## Product Alert Notification (PAN)

**Subject:** Product Marking change  
**Publication Date:** 4/25/2025  
**Effective Date:** 5/19/2025

**DA16200MOD-AAC**

As IS

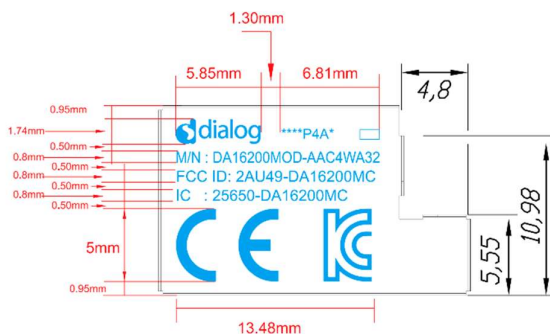
**Description of Change:**  
 Renesas is changing the log on the shield-can because of ANATEL certification.

**Impact on Fit, Form, Function, Quality & Reliability:** The change will have no impact on the fit, function, quality, reliability, and environmental compliance of the products. However, the form in specific the marking appearance is changed as shown in the above images.
